### REMARKS

02-RO-250

10/763,044

Fig. 2

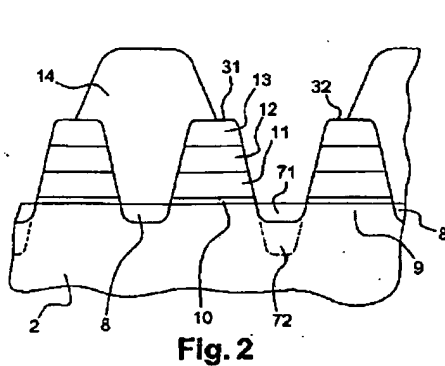
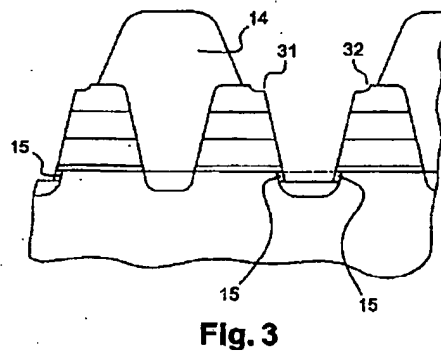
However, the Applicants respectfully disagree with the Examiner's characterization of Subramanian. First of all, Subramanian is completely silent on "an attack of the formation zone and of the protective resin so as to result in a deposit of residue from the protective resin below the precursor stacks" as recited for claim 1.

Nowhere does Subramanian teach an attack of a material located under the precursor stack or the presence of a residue from a previous attack. As shown by the FIGs. 2 and 3 of the present invention below, the formation zone and the protective resin 14 are attacked resulting in a deposit of residue 15 from the protective resin 14 below the precursor stacks 31, 32.

Nowhere does Subramanian teach a deposit of residue 15. Column 7, lines 26-29 of Subramanian cited by the Examiner merely state that the portions of the field oxide regions and the gate dielectric layer between every second pair of adjacent stacked gate structures in the array core are typically removed in preparation for the formation of the common line CS. This is not the same as "an attack of the formation zone and of the protective resin so as to result in a deposit of residue from the protective resin below the precursor stacks", as recited for claim 1. Accordingly, the present invention distinguishes over Subramanian for at least this reason.

FIG. 2C (PRIOR ART)

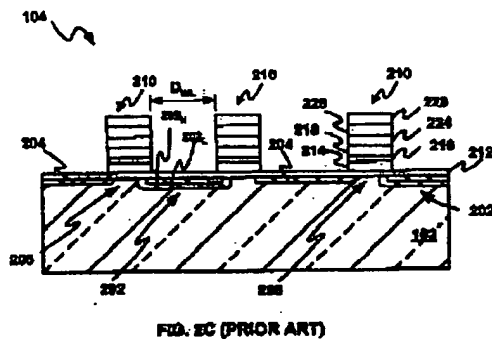
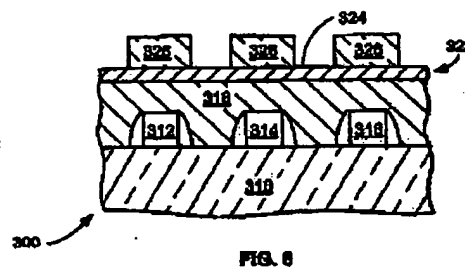
Furthermore, the Examiner included the following figures 2C and 6 from Subramanian to further support the rejections of claims 1-2, 13-14, and 18.

The Examiner points to elements 212 of FIG. 2C and element 318 of FIG. 6 in Subramanian and compares them to the protective resin 14 of the present invention, which is illustrated in FIG. 2 and FIG 3 above. As stated above, Subramanian explicitly teaches that element 212 and 318 are dielectric layers, not protective resins as recited in the claimed invention. Additionally, FIG. 2C of Subramanian teaches that the dielectric layer, which is part of the stacked gate structure 210 (See column 5, lines 39-40), is first deposited then the stacks 210 and the layers of the stack 210 are formed. For example, Subramanian teaches at column 6, lines 31-37 that the dielectric layer 212 is initially formed on the substrate 102 then a layer of conductive polysilicon is formed on top of the dielectric layer 212. Additional layers are then added.

The dielectric layer 212 of Subramanian is below the stack 210; however, this layer is deposited on the substrate before any of the other layers of the stack 210 are deposited. The present invention, on the other hand, recites "an attack of the formation zone and of the protective resin so as to result in a deposit of residue from the protective resin below the precursor stacks". In other words, the precursor stacks are already in place when the residue is deposited below the precursor stacks.

Furthermore, layer 318 is not at any point formed below precursor stacks. Layer 318, which is a dielectric layer, is below an ARC layer 322, which is below a photoresist 326, not a precursor stack. Accordingly, the present invention distinguishes over Subramanian for at least these reasons as well.

Additionally, as stated briefly above, the Examiner compares element 212 of FIG. 2C and element 318 of FIG. 6 of Subramanian to the protective resin 14 of the present invention. The Applicants respectfully point out that element 212 of FIG. 2C and element 318 of FIG. 6 of Subramanian are not the same as the protective layer 14 of the present invention. Elements 212 and 318 of Subramanian are dielectric layers. See column 7, lines 24-25 and lines 59-60 of Subramanian.

Furthermore, the Examiner states that layers 212 and 318 are the same as the protective resin 14 in the present invention. Therefore, Subramanian would have to teach that layers 212 and 318, which are dielectric layers, are removed after implantation of the source line. As can be clearly seen from FIG. 2C, the source line exists and the layer 212 also exists. Accordingly, Subramanian does not teach, anticipate or suggest "removing the protective resin following implantation of the source line".
